### **The Great Grid Upgrade**

Norwich to Tilbury

Environmental Implications of Change –

Essex 9

#### **Image 1: Proposed Change**

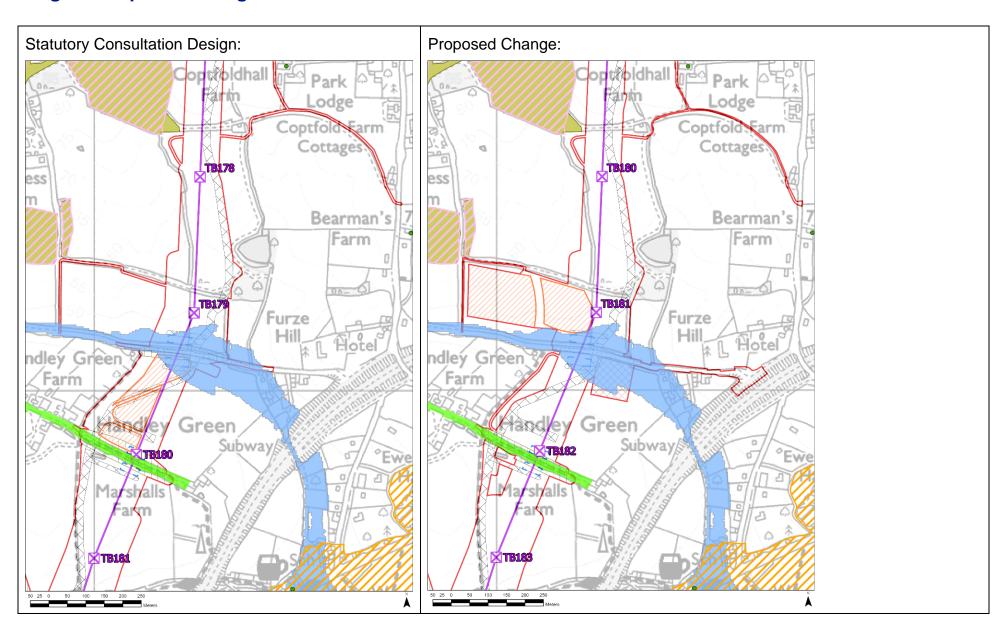
- This Environmental Implications of Change document should be read alongside the associated Essex 9 targeted consultation leaflet.
- 1.1.2 Image 1 presents the Statutory Consultation design and the proposed change together with key environmental constraints using the key below.

Landscape and Visual	The proposed change would move the proposed laydown areas further from property at Handley Green, reducing visual effects during construction, but closer to properties at Ivy Barn. Overall, there would be no change to the type or significance of landscape and visual effects as a result of the proposed change, when compared to the design and PEIR presented at statutory consultation.
Noise and Vibration	There would be no change to the type or significance of noise and vibration effects as a result of the proposed change, when compared to the design and PEIR presented at statutory consultation.
Socio-economics, Recreation and Tourism	There would be no change to the type or significance of socio- economic recreation and tourism effects as a result of the proposed change, when compared to the design and PEIR presented at statutory consultation.
Traffic and Transport	There would be no change to the type or significance of traffic and transport effects as a result of the proposed change, when compared to the design and PEIR presented at statutory consultation.
